**Re: Draft Clare County Development Plan 2023-2029  
Amendments Stage Submission re Lands at Kilkee, County Clare.**

This submission relates to the Material Alteration proposed to the **Kilkee Land Use Zoning Map**, as outlined at page 71 of *Volume 3d – West Clare Municipal District Settlement Plans Proposed Amendments*.

## Hydrological Assessment

LOCATION: Kilkee, Co. Clare  
PREPARED FOR: Declan Cunningham, [REDACTED]  
PREPARED BY: Colin O'Reilly PhD (Hydrology)  
DATE: 30th December 2022  
REFERENCE: 2085 v2

Figure 3

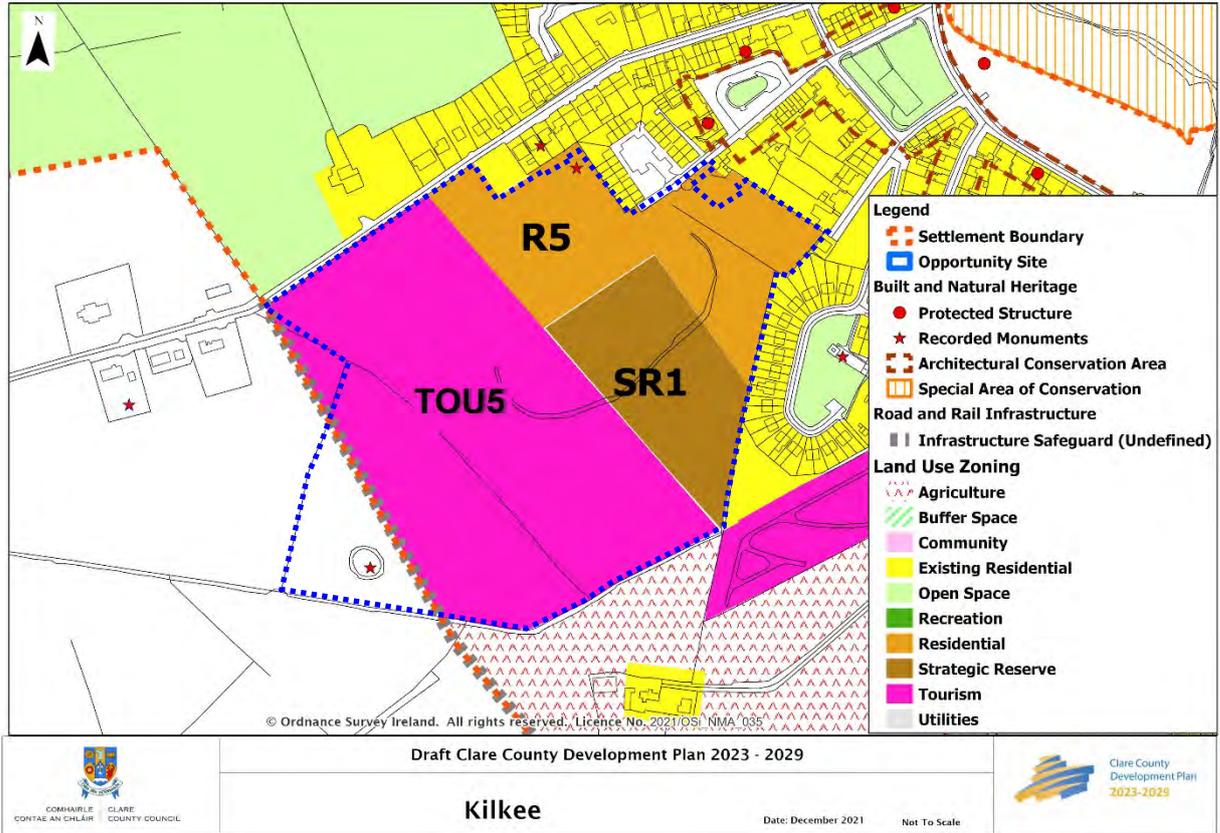
The Kilkee Settlement Plan Land Use Zoning Map as contained in the Draft Clare County Development Plan 2023-2029 presents a change in the zoning of the lands, see figure 3 below. The zoning map identifies the subject lands as zoned for 'Tourism' purposes (Site TOU 5), 'Residential Purposes' (Site R4 and R5) and 'Strategic Residential Reserve' (Site SR1).

The Kilkee Settlement Plan Land Use Zoning Map as contained in the Draft Clare County Development Plan 2023-2029 Proposed Amendments indicates that the Planning Authority proposes to change the zoning of a portion of the 'Strategic Residential Reserve' (Site SR1) lands and a portion of the Tourism lands (Site TOU 5) adjoining to 'Buffer Space' zoning, see figure 4 below. The area in question amounts to 0.16ha approx..

The Planning Authority is requested to adopt the land use zoning objectives affecting our client's lands as detailed in the Kilkee Settlement Plan Land Use Zoning Map included at page 51, Volume 3d, of the Draft Clare County Development Plan, published on 10<sup>th</sup> December 2021.

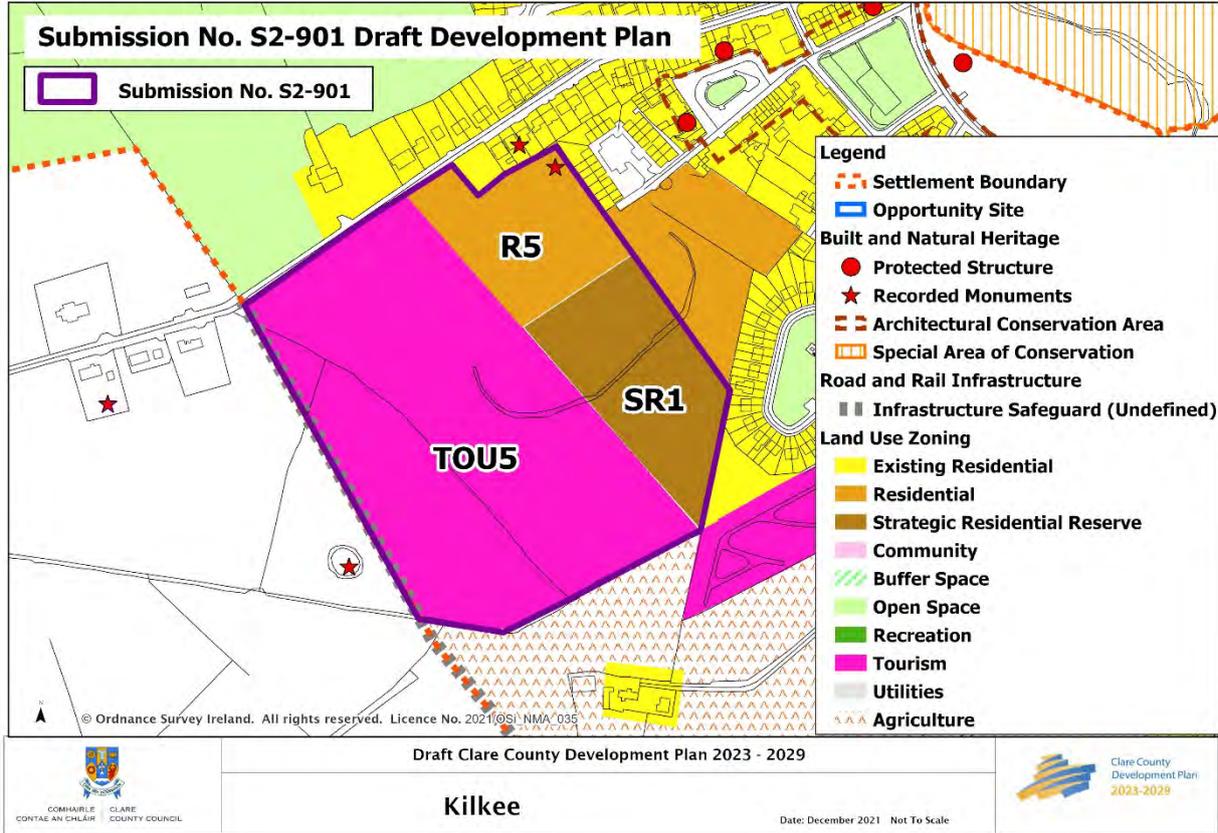
<b>Chief Executive’s Response</b>	
<p>I want to thank Kevin Heenan &amp; Joseph McCloskey for this submission and I wish to address the issues raised as follows:</p> <p><b>Flood Risk:</b></p> <p>The Settlement Based Flood Risk Assessment for Kilkee (contained within Volume 10c Strategic Flood Risk Assessment of the draft CDP) includes a map of the Flood Risk Zones at Kilkee. There is a mapped Flood Risk zone at this location but there is a very minor overlap of the Flood Risk zone with the TOU5 and SR1 lands, at the location where TOU5 and SR1 adjoin each other and the existing mobile home park at the southeast side of the subject lands.</p> <p>Having regard to the content of the submission, I have consulted with the Council’s Flooding Consultant regarding these sites. Their response is as follows:</p> <p style="padding-left: 40px;"><i>“This site is significantly elevated and not directly connected to the nearby watercourses. Flooding evident on site is likely to be from surface water ponding and should be managed in accordance with the guidance for development in Flood Zone C. The lower (southern) part of the site is vulnerable to inundation from the Well Stream, and is identified to form part of the Kilkee FRS options. It is recommended that this lower part of the site is rezoned to a water compatible use and not developed. See Kilkee tab for details of extent to be rezoned.”</i></p> <p>The “extent to be rezoned” is shown on a map prepared by the consultant. The identified Flood Risk Zone is more extensive than that shown in Volume 10c Strategic Flood Risk Assessment of the draft CDP.</p> <p>I consider that the identified flood risk relating to TOU5 and SR1 represents significant uncertainty. I consider that an area of c. 0.16ha at the southern end of TOU5 and SR1 is zoned as Buffer Space. The c.0.16ha area is divided equally between TOU5 and SR1.</p>

The section of the TOU5 and SR1 lands that has been identified as at risk of Flooding is amended to Buffer Space.

In summary, the detailed and technical Hydrological Appraisal of the proposed zoning amendment confirms that Clare County Council must not adopt the proposed material amendment to the Draft Development Plan as detailed in the Kilkee Settlement Plan Map, published on 28<sup>th</sup> November 2022.

**Figure 16 - Proposed Embankment between Caravan Park and Subject Lands Proposed under Kilkee FRS**

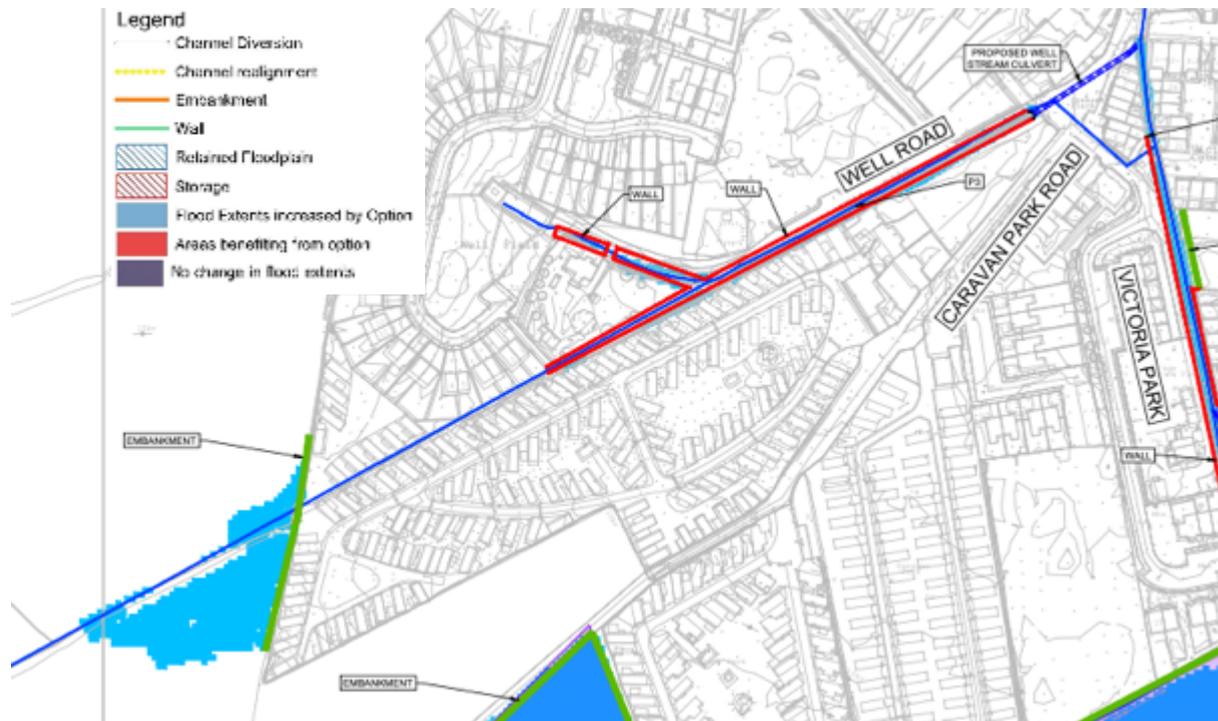
The impact of the proposed embankment on the subject lands is largely dismissed given the current greenfield condition. The proposals ignore the intention of Mr Cunningham to extend the caravan park westwards into this area, as evidenced by his recent planning application.

- The Kilkee FRS shows that the flood area at the southeastern corner of the subject lands is newly created, only arising following installation of an embankment, which is one of the options being proposed. The Kilkee FRS does not show this to be an area already at risk of flooding. Hence assigning land use zoning based on an FRS which is still at design phase is premature.

Figure 19 – Amended Land Use Zoning as Per Draft Amended Clare County Development Plan 2023 – 2029

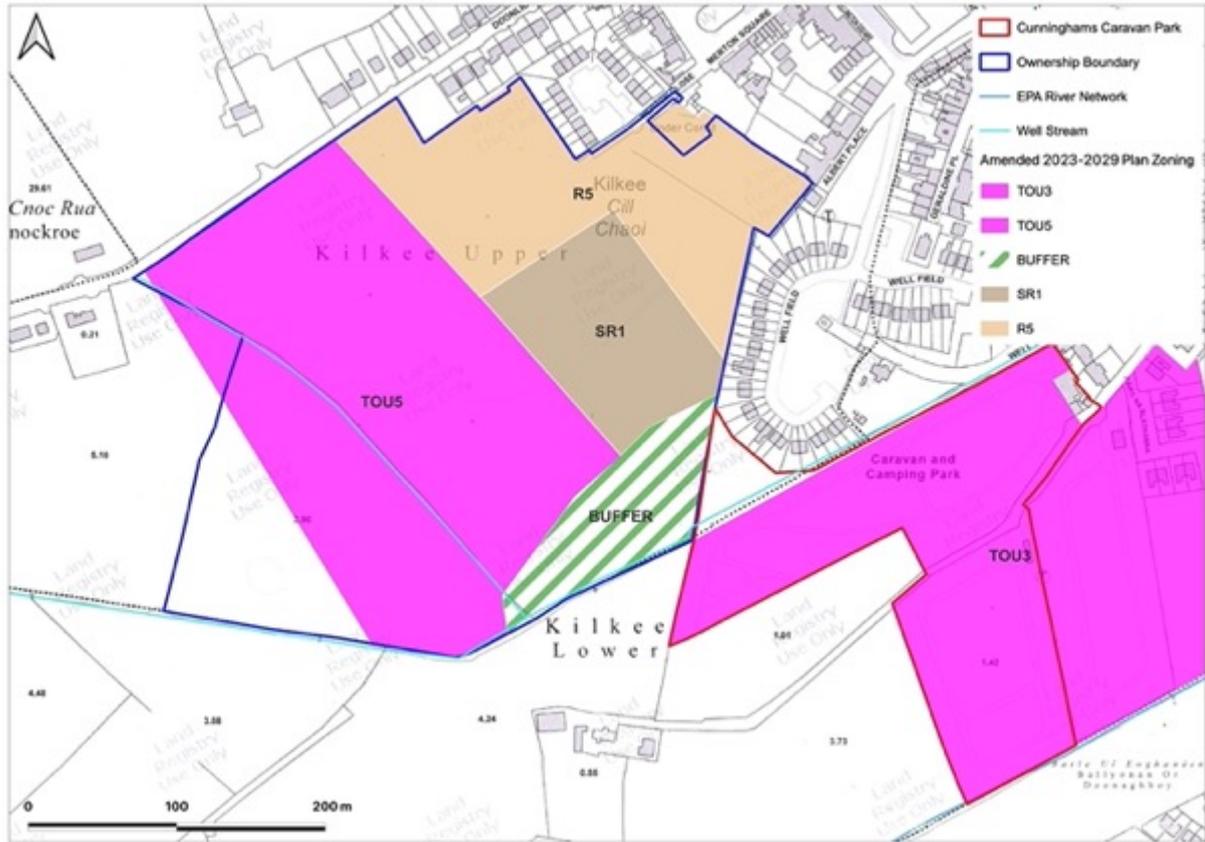
- The recommendation to rezone the lower southeastern corner of the site to 'a water compatible use and not developed' is entirely unjustified.
- Any such proposal should be determined as part of a site-specific flood risk assessment which will allow the analysis of site-specific flood alleviation measures such as compensation storage and would provide analysis of suitable land uses such as an access road connecting the caravan park to the subject lands.

- The map referred to as having been prepared by the consultant is not available for review. The hydrological basis for determining flood risk areas has not been presented.

- The Buffer Zone extends across the entire western boundary of the caravan park which will make it almost impossible to extend westwards into the subject lands. The buffer zone will effectively sterilise the subject lands to the rear.

Envirologic advise that the proposal for implementing the Buffer Zone land use be removed and that land use zoning should be maintained in line with the current draft development plan. The primary reasons are presented in detail in the previous section, summarised as follows:
